WM-10
PDR
(Return to WM, 623-SS)

July 22, 1982

Dr. Robert Wright
U.S. Nuclear Regulatory Commission
M.S. 697 SS
Washington, D.C. 20555

Figure 1. Trilinear plot of lower Saddle Mountains/Wanapum composite and Wanapum wells from RHO reply figures 1 and 3.

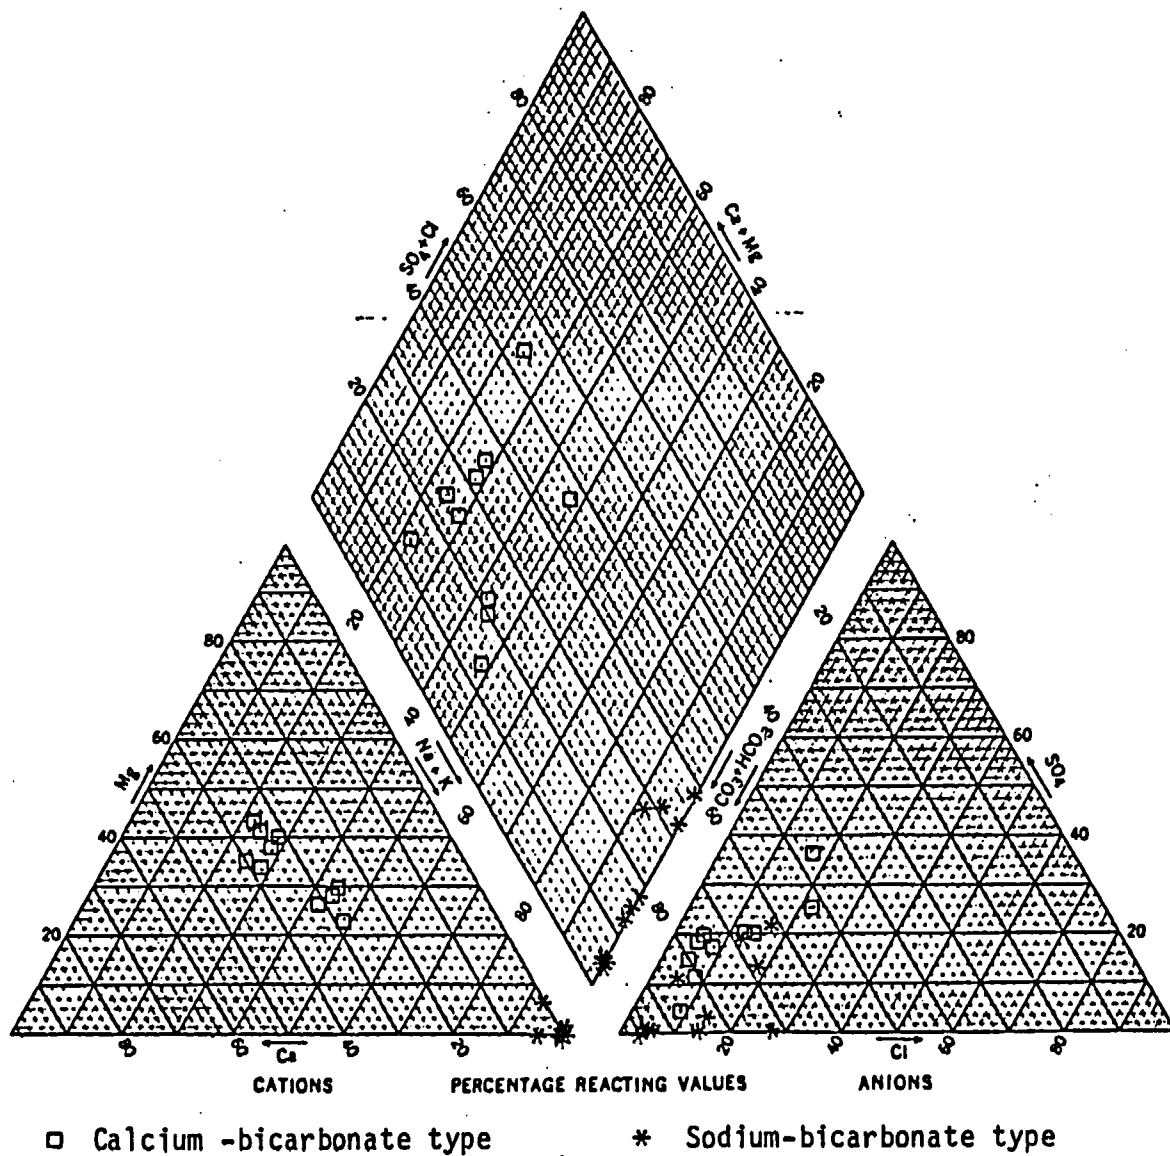
I was particularly intrigued by the here-to-fore unavailable data that was included in the Rockwell reply. If our mixing hypothesis is correct, the "new" data taken from the Pasco Basin area should support this premise. As a test, I have plotted the "new" data on Piper trilinear diagrams. Figure 1 plots only the wells RHO designates as 1) composite - lower Saddle Mountains/Wanapum (LSM/WP) and 2) Wanapum (WP). This plot illustrates the distribution of water within one hydrostratigraphic interval. According to RHO, this should be one water type only.

From Figure 1, it can be seen that the (LSM/WP) and the (WP) plot as two distinct water types; a Calcium-Bicarbonate type and a Sodium-Bicarbonate type. The areal distribution of these types is shown as Figure 2. As can be seen, the Sodium-Bicarbonate type falls within the central Pasco Basin. The Calcium-Bicarbonate type surrounds this area.

Figure 3. Trilinear plot of all data on RHO reply figures 1 and 3.

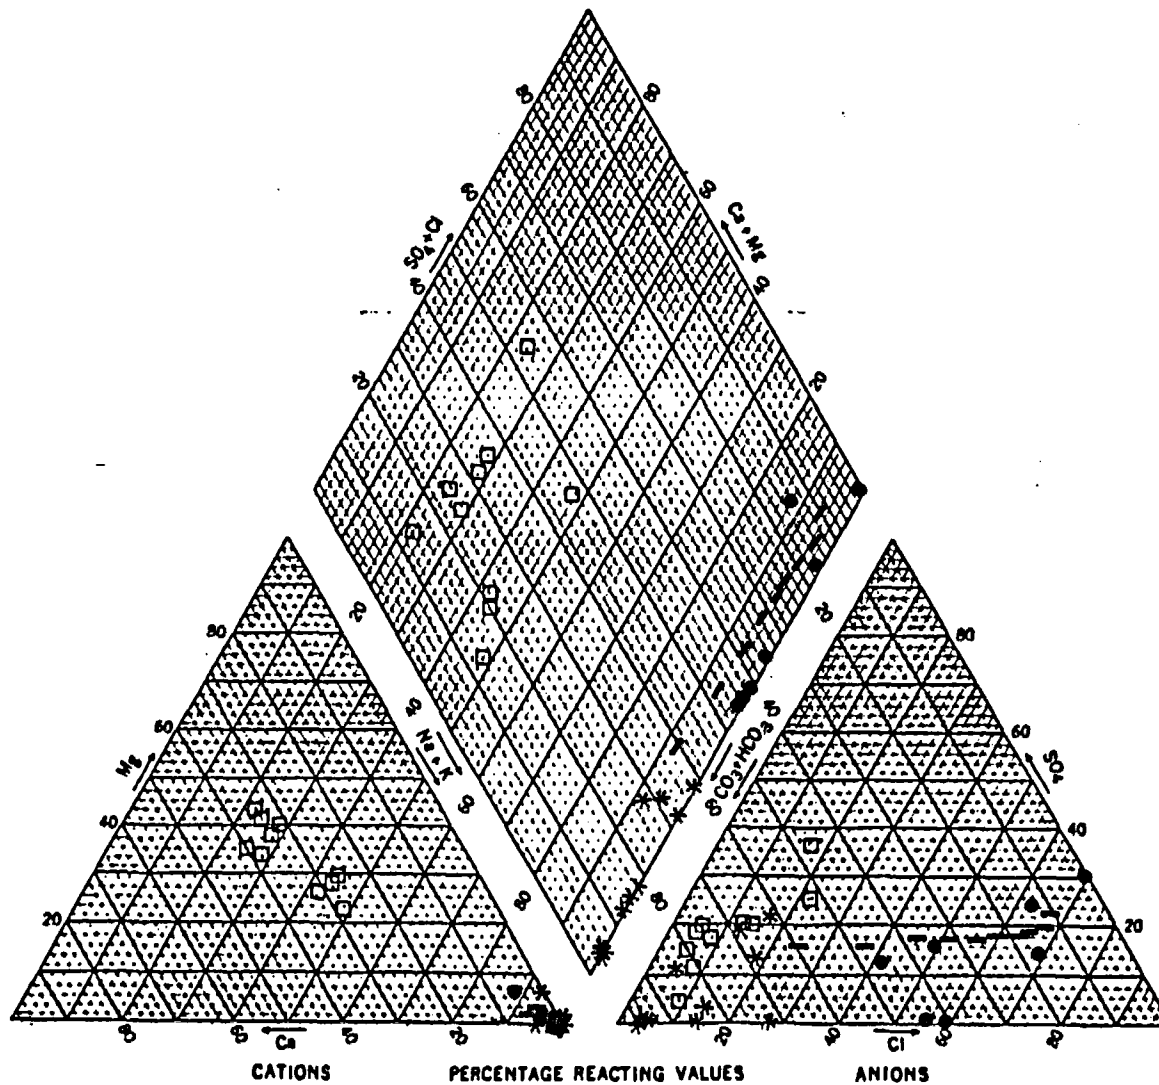
Figure 3 is a plot of all data from Figures 1 and 3 of the Rockwell reply. The additional deep data from the Grande Ronde/Lower Wanapum (GR/LWP) plots as a dominantly Sodium-Chloride-Sulfate type. However, the data points do not tightly cluster as a distinct group, but rather plot on a straight line towards the Sodium-Bicarbonate type. This linear trend is an indicator of mixing between the (GR/LWP) water type and the Sodium-Bicarbonate type within the central Pasco Basin. Notice that no mixing trend is evident between the Calcium-Bicarbonate type and the (GR/LWP) type.

In order to confirm that this mixing trend was real, the USGS water chemistry code "WATMIX" was utilized. This code requires as input, water chemistry from the two types of water that are suspected to be mixing. I used the chemistry data from Well DC-14 (GR) and Well 45 from the geochemistry paper. The WATMIX code calculates theoretical mixing between the two water types. As output, the code will tell you what the theoretical chemical mixture would look like from mixes of 100% DC-14 - 0% Well 45 to 0% DC-14 - 100% Well 45 in 10% increments. This chemistry, when plotted on a trilinear diagram, will

be the line the real data should follow if true mixing is occurring. This theoretical mixing line is plotted as X's on Figure 3. It can be seen that the field data plot exactly along this line.

Figure 4. Trilinear plot of all available data in Pasco Basin area.

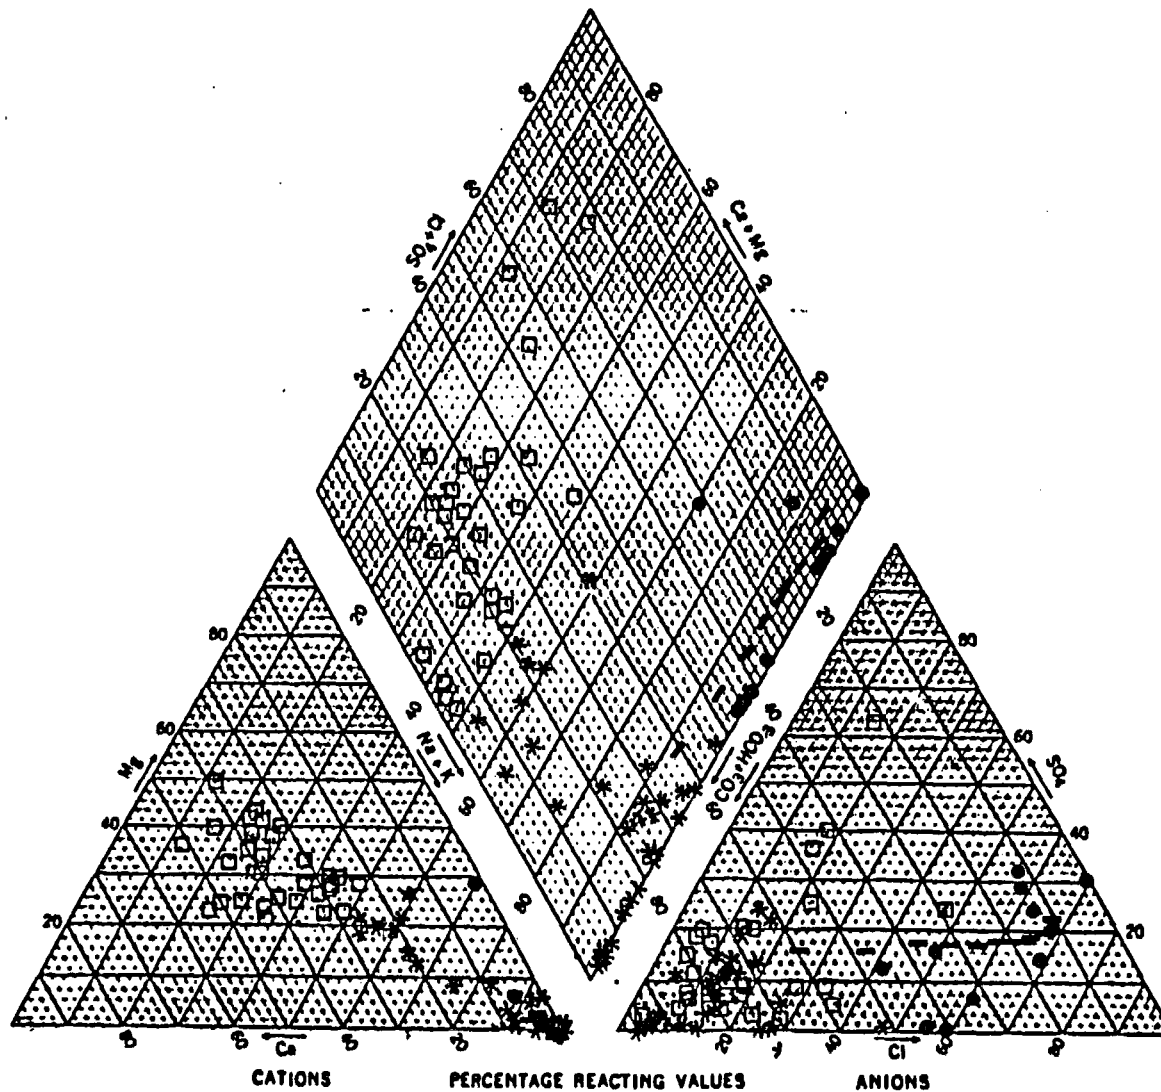
Figure 4 is a plot of all available data (RHO reply plus our geochemistry data appendix) for wells lying in the Pasco Basin and immediately adjacent areas. When plotted, this data indicates an additional mixing trend. That of Sodium-Bicarbonate type water mixing with the Calcium-Bicarbonate type. This trend could be the result of cation exchange of calcium for sodium in clays along the flow path. Due to the completeness of the exchange, however, I believe mixing is more probable. Obviously, some combination of the two is also possible.

Figure 5. Conceptual Geochemical Model.

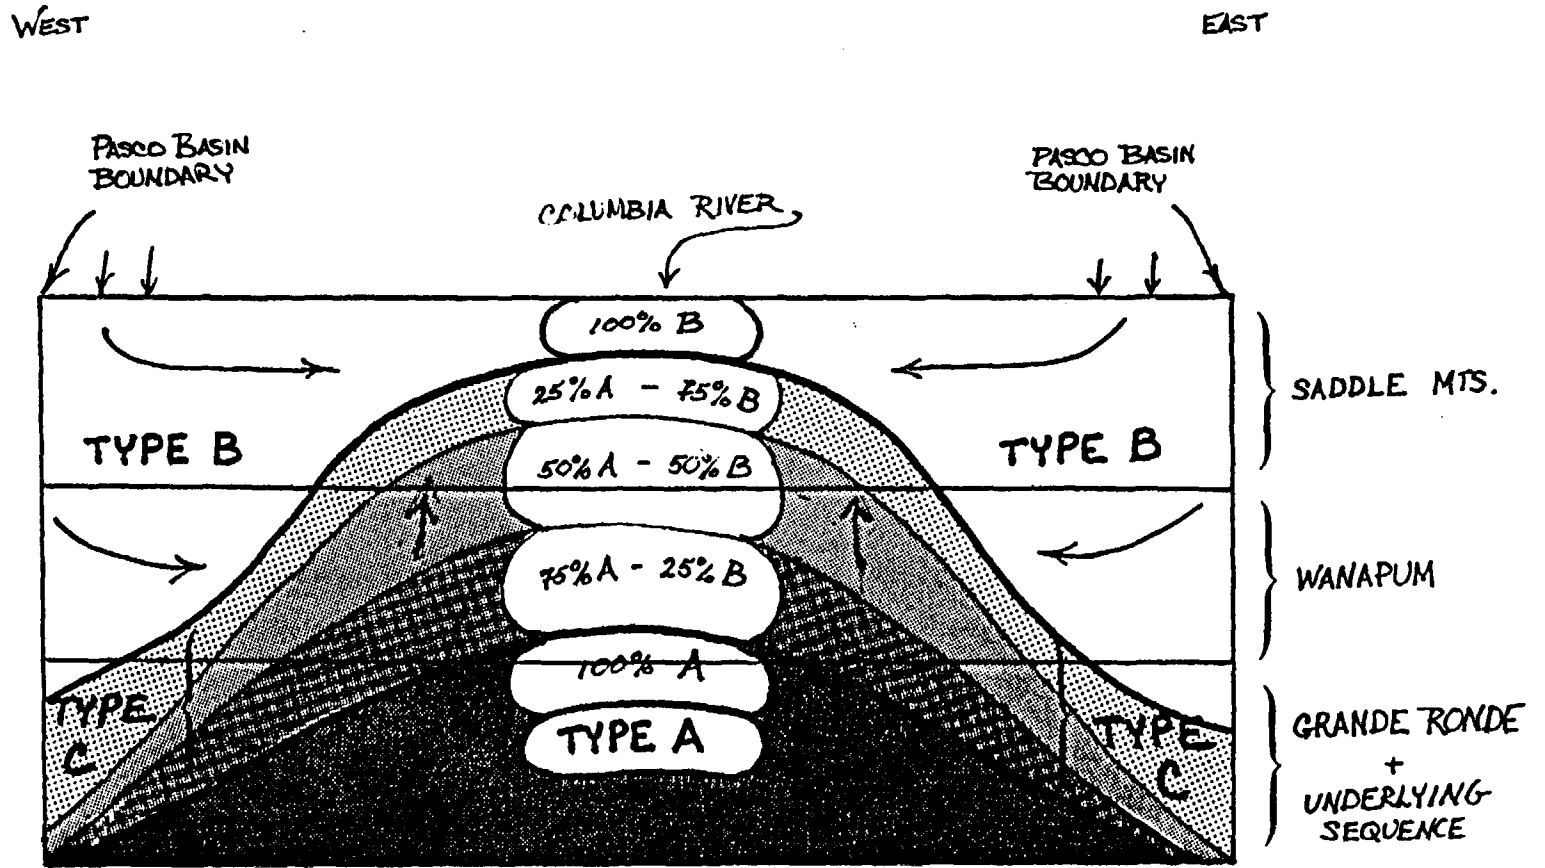
A plausible geochemical conceptual model emerges as a result of these previous four figures; and is shown schematically as Figure 5. For ease of interpretation the water types have been designated as A, B and C. The Calcium-Bicarbonate type is B; the Sodium-Chloride-Sulfate type is A; and the Sodium-Bicarbonate type is C. Figure 5 demonstrates the mixing hypothesis; i.e., $A + B \rightarrow C$.

The sodium within the type C water comes from the Sodium-Chloride-Sulfate water type A. The bicarbonate in the type C water comes from the Calcium-Bicarbonate water type B. The type C water is actually a gradual mix of A and B going from 100% A - 0% B to 0% A - 100% B, progressing upward through the geologic section.

BOREHOLE: DC-14
GROUND SURFACE ELEVATION
119m ABOVE MSL

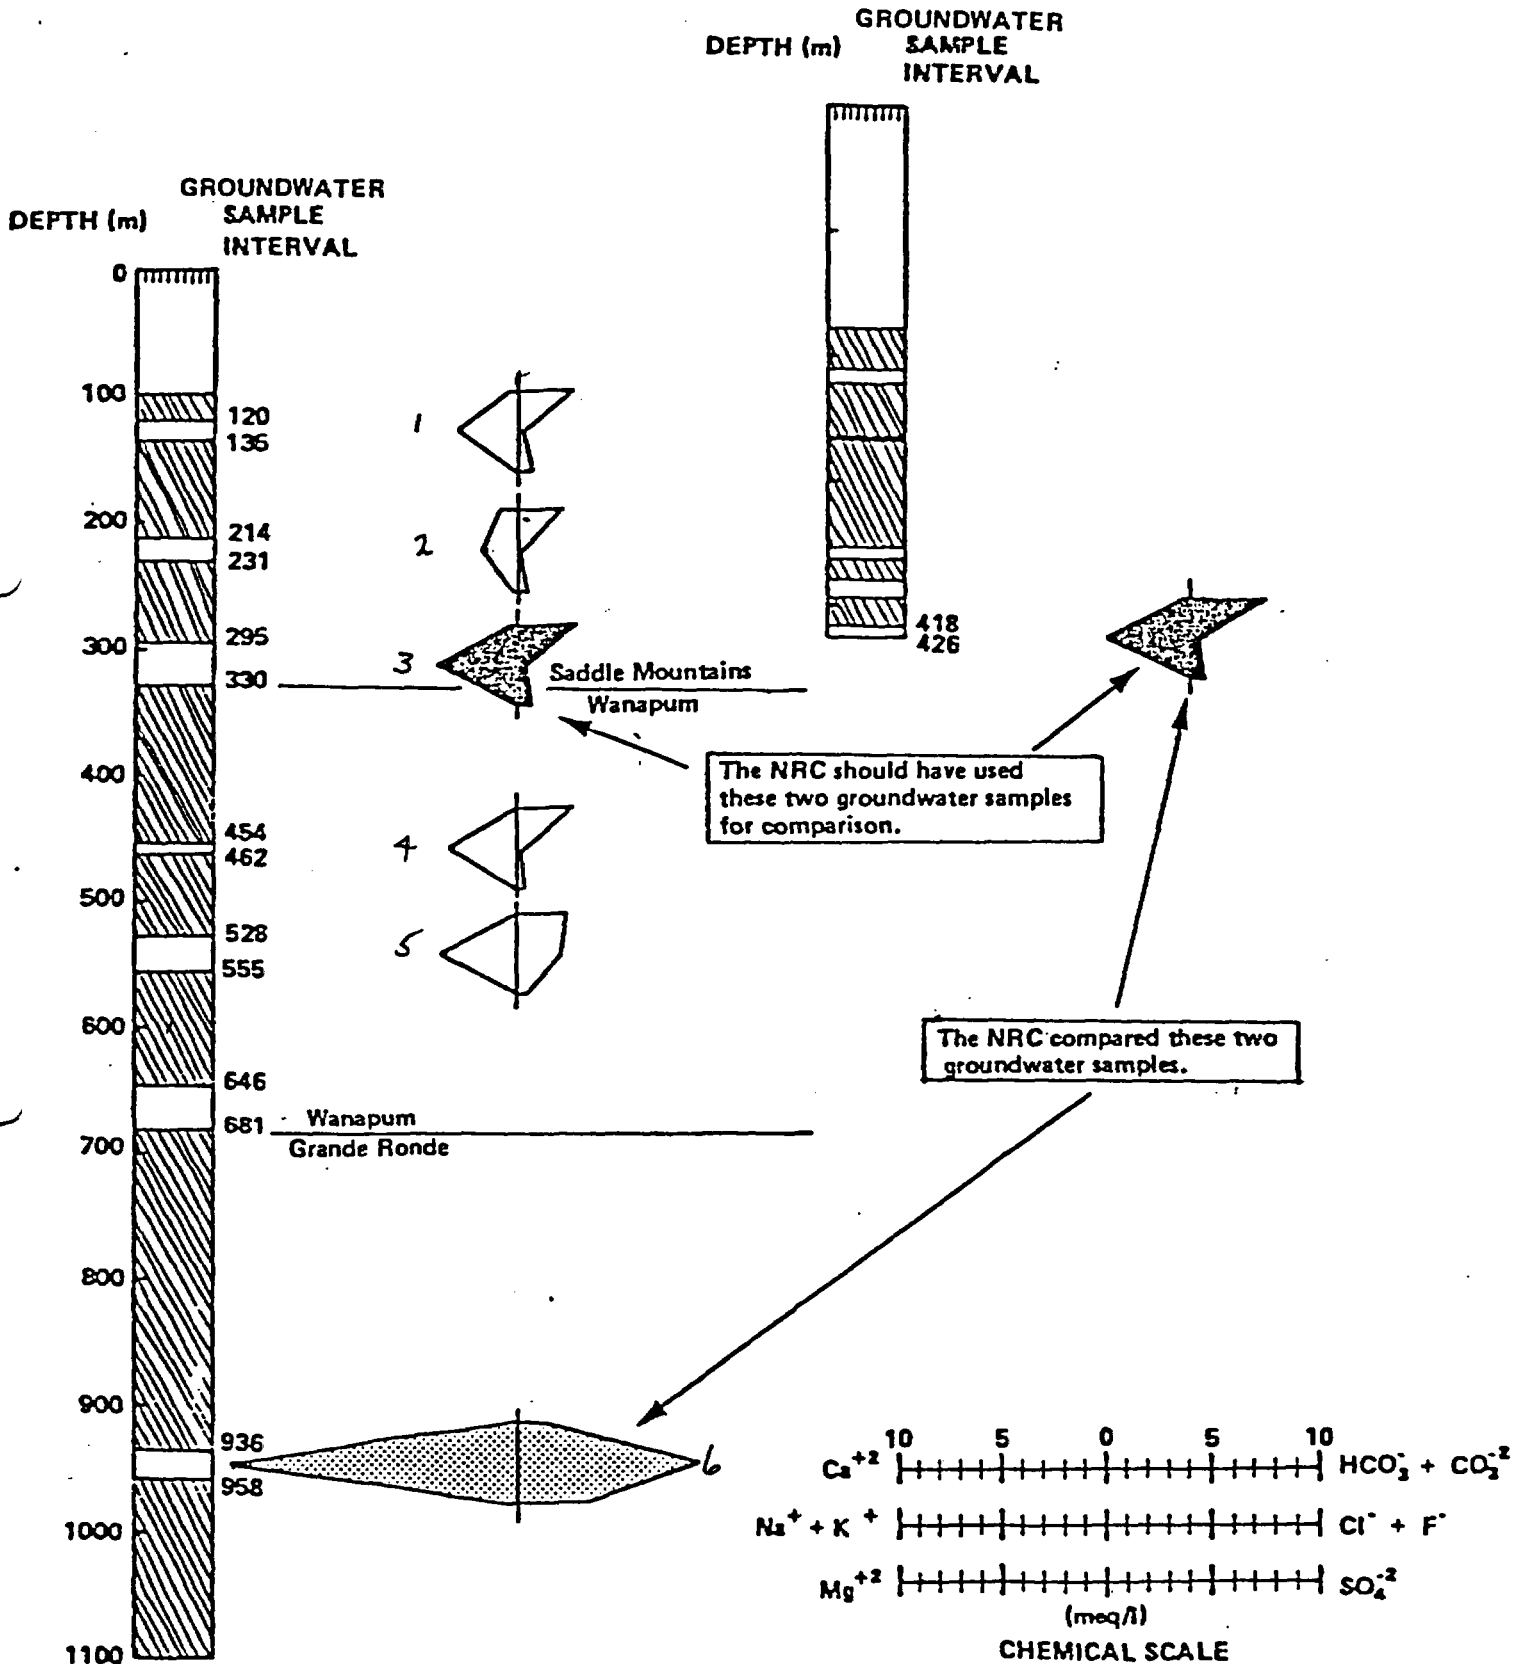
The NRC should have used these two groundwater samples for comparison.

The NRC compared these two groundwater samples.
